Product Change Notice (PCN)

PCN Number: **PCN-0456171R-01**

Product(s) Affected: **PJ-031DH**

PREVIOUS CUI DEVICES DETAIL / IMAGE	NEW CUI DEVICES DETAIL / IMAGE

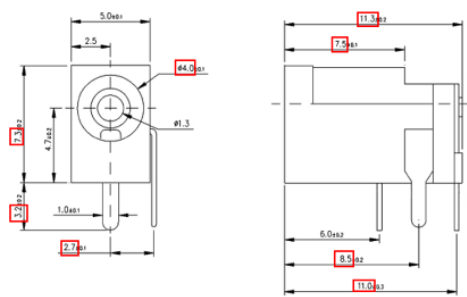
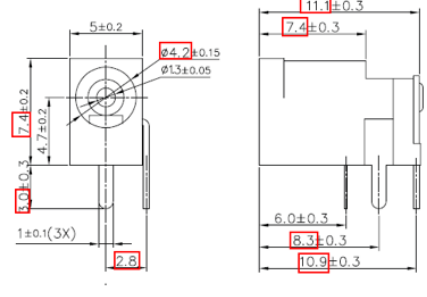
Description of Change: **Product re-engineered for improved manufacturability and production yield. See image below for product changes. Cosmetic differences may be visible and not affect the form fit and function of the product.**

<p>Recommended PCB Layout Top View</p>	 <p>Recommended PCB Layout Top View</p>

PREVIOUS CUI DEVICES DETAIL / IMAGE			NEW CUI DEVICES DETAIL / IMAGE		
DESCRIPTION	MATERIAL	PLATING/COLOR	DESCRIPTION	MATERIAL	PLATING/COLOR
center pin	brass	silver	center pin	brass	CuSn
terminal 1	brass t=0.50	silver	terminal 1	brass t=0.40	silver
terminal 2	MM alloy t=0.20	silver	terminal 2	stainless steel t=0.20	silver
terminal 3	brass t=0.50	silver	terminal 3	brass t=0.40	silver
housing	PA10T (UL94V-0)	black	housing	PA10T (UL94V-0)	black
<p>MATING PLUG Jack Insertion Depth: 7.0 mm</p>			 <p>MATING PLUG Jack Insertion Depth: 6.2 mm</p>
